Project **IEEE 802.16 Broadband Wireless Access Working Group** <<http://ieee802.org/16>>

Title **Notification of Completion for EAP-based Authorization Procedure**

Re: IEEE P802.16e/D8

Purpose Adoption of proposed changes into P802.16e/D8

Figure 1 Existing EAP-based authorization procedure

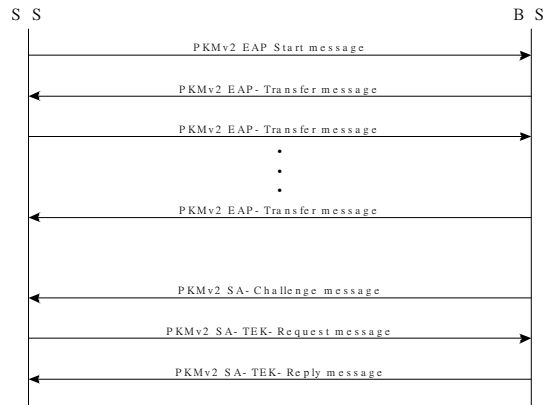
The BS doesn't know the completion time of the EAP-based authorization procedure in case that EAP protocol doesn't yield AAA-key.

In addition, the BS doesn't know whether an MS receives the last PKMv2 EAP Transfer message (including AAA-key, such as "EAP Success" used in EAP-TLS) or not. Both the BS and an MS cannot share the AK derived from PMK simultaneously, when an MS doesn't receive the last PKMv2 EAP Transfer message. Even though an MS receives the last PKMv2 EAP Transfer message, there may be possibility of an MS's MAC receiving the PKMv2 SA-TEK-Challenge message from the BS before getting the AAA-key from MS's EAP method layer, because the BS can almost simultaneously send the last PKMv2 EAP Transfer message and PKMv2 SA-TEK-Challenge message. The existing EAP-based authorization procedure is shown in Fig 0.1.

We provide a new PKMv2 EAP Transfer Complete message to notify that an MS receives the last PKMv2 EAP Transfer message. An MS will send a PKMv2 EAP Transfer Complete message to the BS. As soon as the BS receives this message, the BS will send a PKMv2 SA-TEK-Challenge message to an MS.
